Proposed development: Full Planning Application (Regulation 3) for Extension to existing staff and visitor car park

**Roe Lee Park Primary School
Emerald Avenue
Blackburn
BB1 9RP**

Applicant: Blackburn With Darwen Borough Council

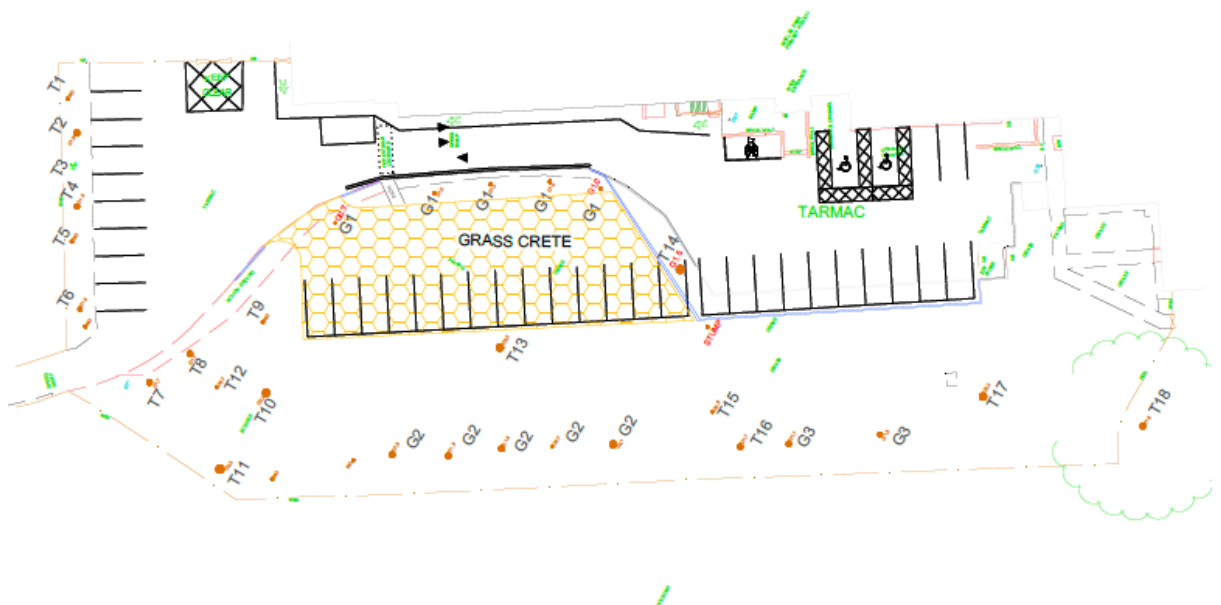
The proximity of the proposed 'Grasscrete' (or similar) has potential to impact on the rooting area of the mature Horse Chestnut T13. The proposed installation should not include any excavations below 200 mm i.e. removal of grass, turf.

The proposed car par area is gently undulating and there is a notable raise in level from the existing access to the application site surface. Establishing levels and the installation of the Grasscrete may conflict with the rooting area of T13.

The Design and Access Statement refers to MOT sub-base. The correct sub-base material is required to ensure there is a permeability for tree rooting areas. Suitable sub-base materials include, 4/20 and Type 3 sub-base.

The proposed 'Grasscrete' or similar, are rarely successful in establishing an affective grass sward, particularly if there is shading from trees, resulting in a patchy appearance between visible concrete. For these reasons it would be worth considering other alternative permeable surfaces.

The new kerbing appears to lead towards the existing kerbing adjacent to T14. Which appears to provide an upstand between the existing surfacing and the proposed grass create. It is recommended that both the existing and proposed surfacing is level across the carpark.

- 4.3.6 On the information presently available, the Arboricultural Officer advised that a condition should be attached for a method statement for the installation of the car park, to include levels. It is also considered appropriate to attach a condition for clarity of the proposed surfacing, to ensure the most suitable permeable surfacing is used for this scheme, and to minimise impacts on existing trees, whilst also ensuring the surfacing is suited for traffic and including refuse collection and emergency vehicles. BwD Highways have indicated that either Grasscrete or GeoWeb would be acceptable from a highways perspective.

A condition for a method statement for the installation would be appropriate with any approval of the application. This should include levels.
